RE: **Juan Tabo Hills Estates**

Engineer's Certification – Accepted

Revised Grading Plan Stamp Date: 9/7/18

Hydrology File- M21D018; DRB# 1005278

*JUAN TABO HILLS ESTATES
GRADING & DRAINAGE PLAN*

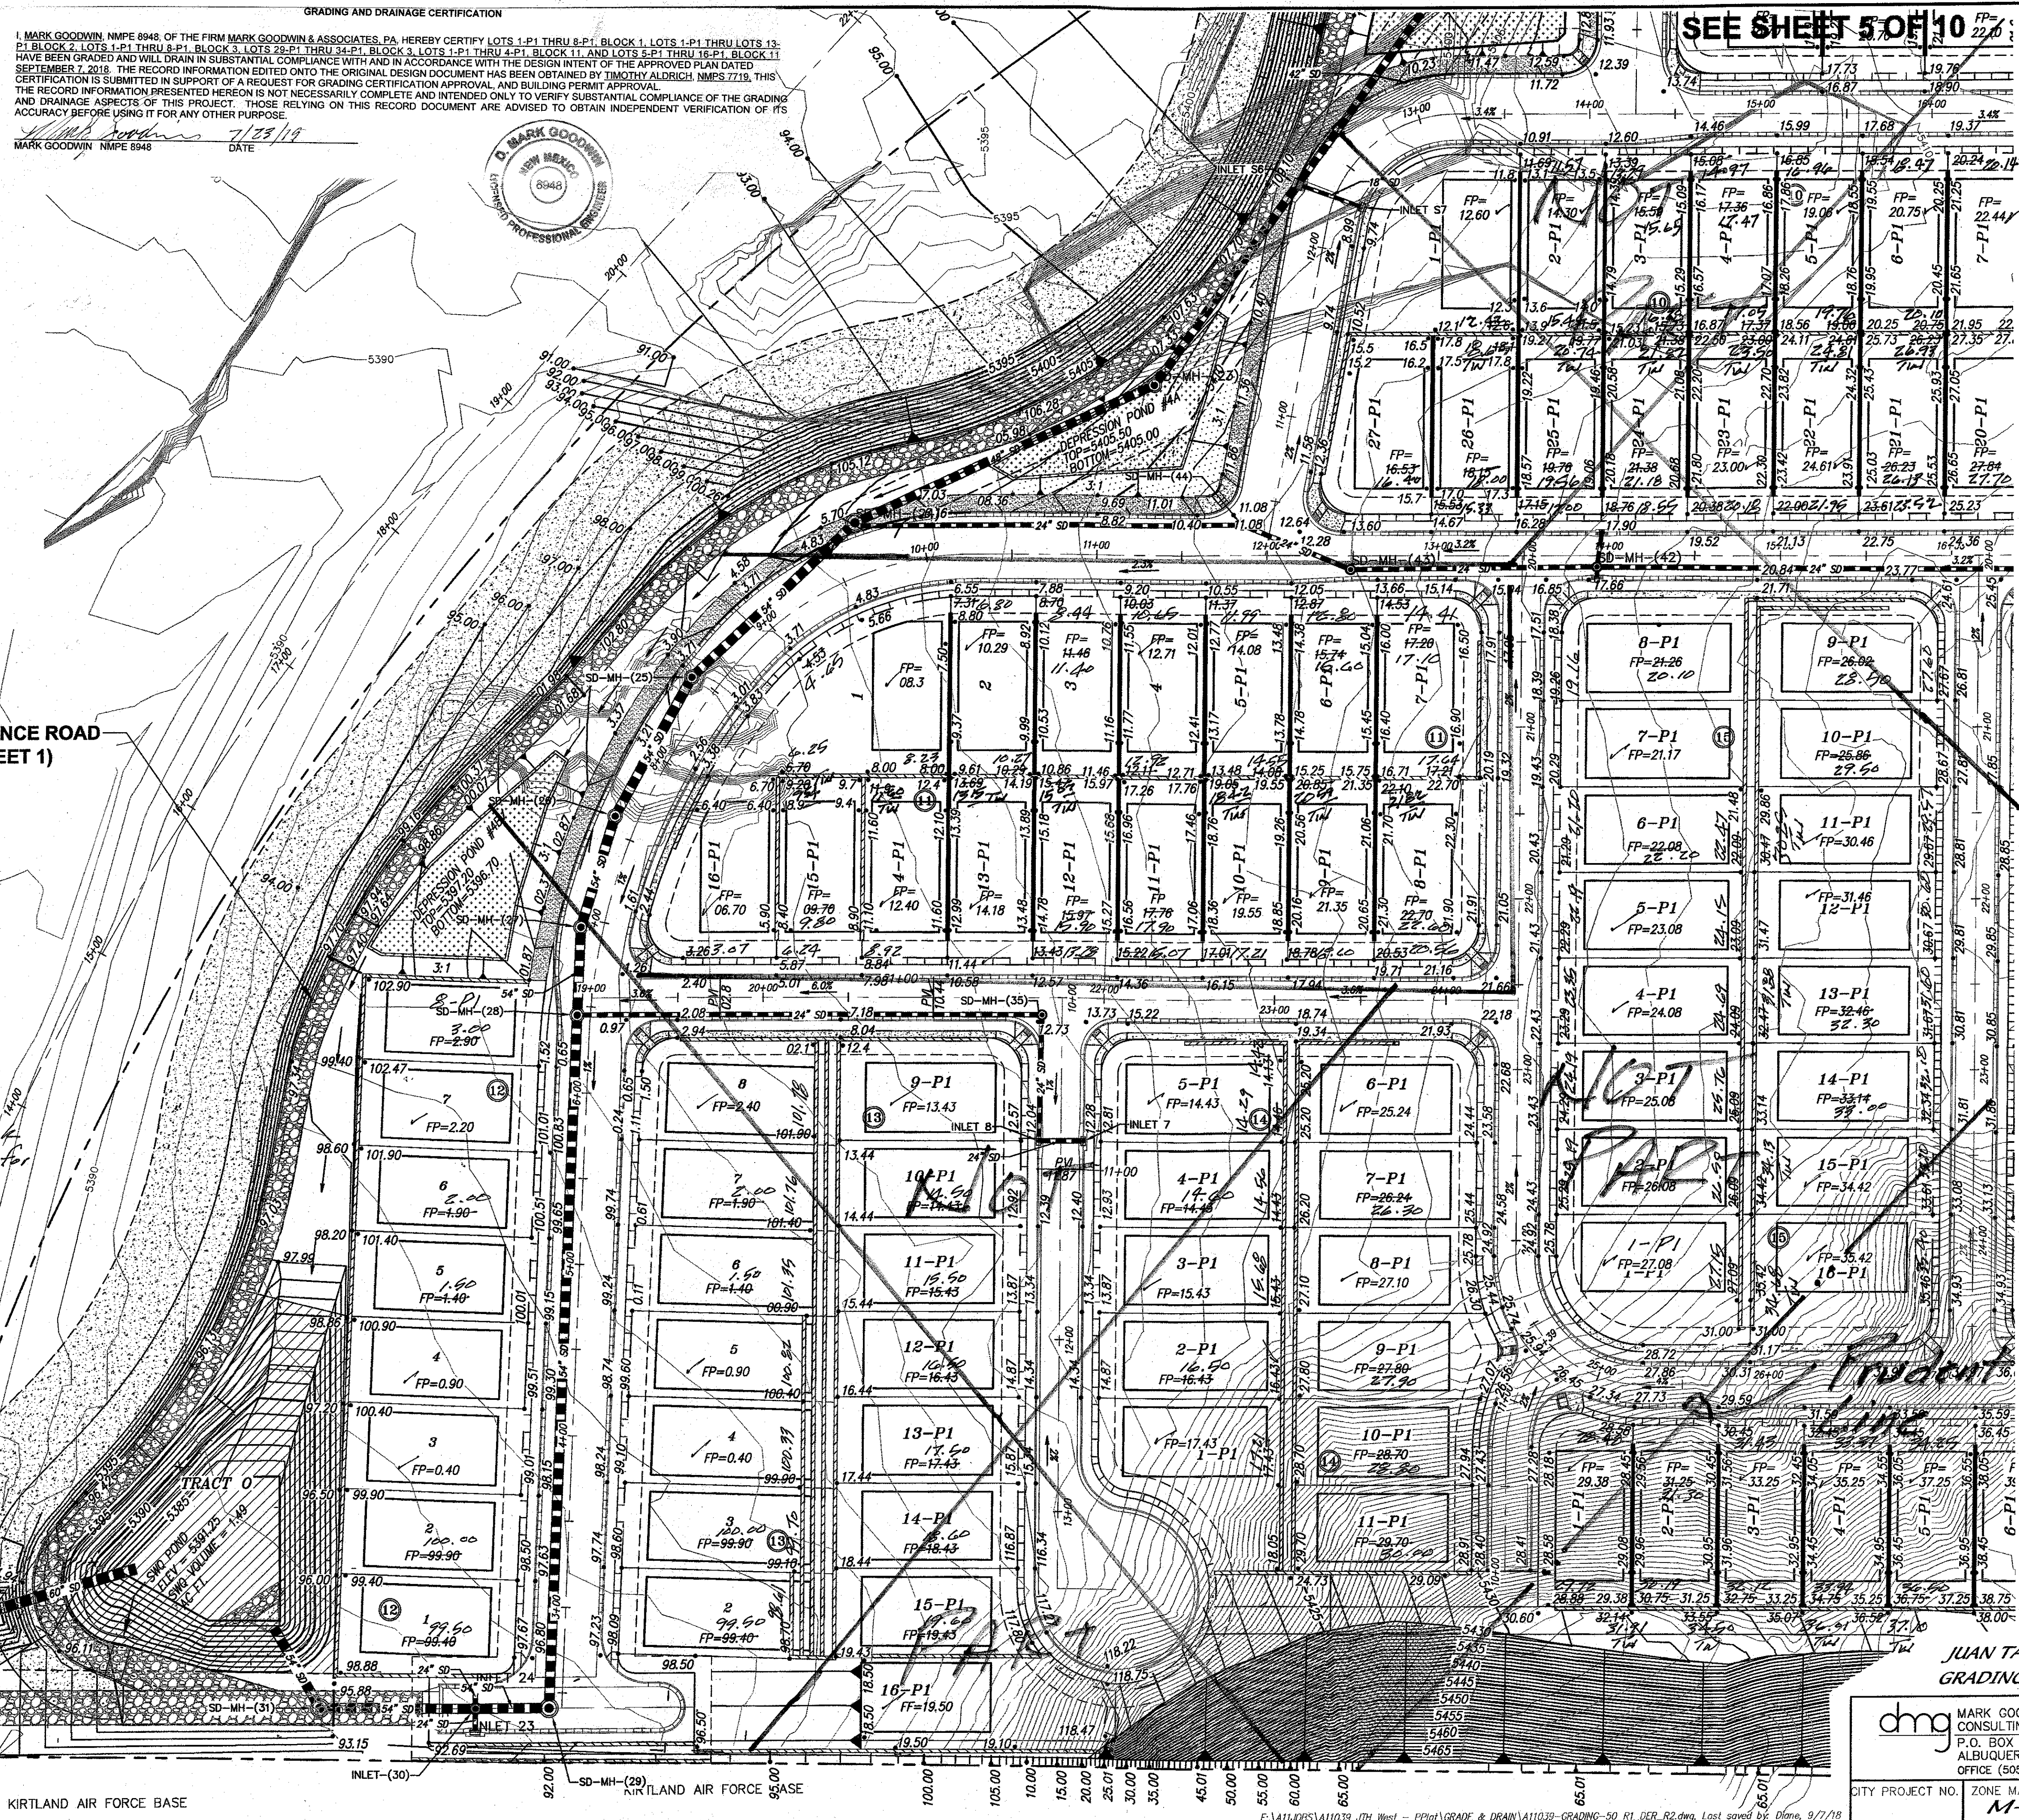
Based on the submittal received on 7/23/19, the above referenced Pad Certifications are accepted for Building Permit.

Please note that these lots are within the Prudent Line developed by Leedshill-Herkenhoff, 1990 (*Tijeras Arroyo DMP Phase II*). Home construction is not recommended within the Prudent Line until the Bank Protection is in place and accepted by AMAFCA and the City. If the Developer decides to build on these lots he does so at his own risk and against the recommendation of City Hydrology.

Prior to Pad Certification for Lots 33P1 and 34P1, Block 3, the common retaining wall must be constructed and certified. If you have any questions, you can contact me at 924-3695 or dpeterson@cabq.gov.
